Access Compliance Report

Public Rights-of-Way

Intersection ID: 29700	Main Street: CAMERON_CREEK_DR	Cross Street: WEDDINGTON_RIDGE_LN	Location: S
ADA ID: 23E99B428A7A	Ramp Type: Perp	Initial Pass/Fail: Fail	Overall Compliance: No
Severity Score: 12.5			
Codes/Mitigation Info/Possible Solution		Field Measurements/Component Compliance

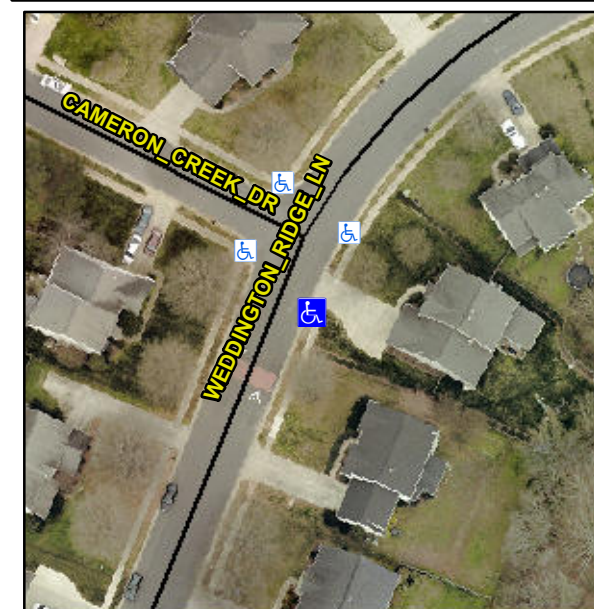
Not Found, R304.2.2

Compliance	Description	Data	Compliance	Description	Data
N/A	Ramp Length (in)	48.0	No	Ramp Slope (%)	10.7
Yes	Ramp Width (in)	48.0	Yes	Ramp XSlope (%)	0.6
N/A	Flare Type LT	N/A	N/A	Flare Type RT	N/A
N/A	Flare Slope LT (%)	N/A	N/A	Flare Slope RT (%)	N/A
N/A	Flare Traversable LT?	N/A	N/A	Flare Traversable RT?	N/A
N/A	Landing Length (in)	N/A	N/A	DWS Provided?	N/A
N/A	Landing Width (in)	N/A	N/A	DWS Contrast?	N/A
N/A	Landing Slope (%)	N/A	N/A	DWS Length (in)	N/A
N/A	Landing X Slope (%)	N/A	N/A	DWS Full Width?	N/A
N/A	Landing Curb? (Y/N)	N/A	N/A	DWS Offset (in)	N/A
N/A	Shared Landing?	N/A			
N/A	Gutter Ponding?	N/A	N/A	Gutter Slope (%)	N/A
N/A	Gutter Lip Ht (in)	N/A	N/A	Gutter X Slope (%)	N/A
N/A	Painted X Walk1?	No	N/A	Painted X Walk2?	N/A
	X Walk 1 Direction	To NW		X Walk 2 Direction	N/A
N/A	X Walk 1 Width (in)	N/A	N/A	X Walk 2 Width (in)	N/A
	X Walk 1 Slope (%)	3.9		X Walk 2 Slope (%)	N/A
	X Walk 1 X Slope (%)	0.8		X Walk 2 X Slope (%)	N/A

Remove & Replace Entire Ramp.
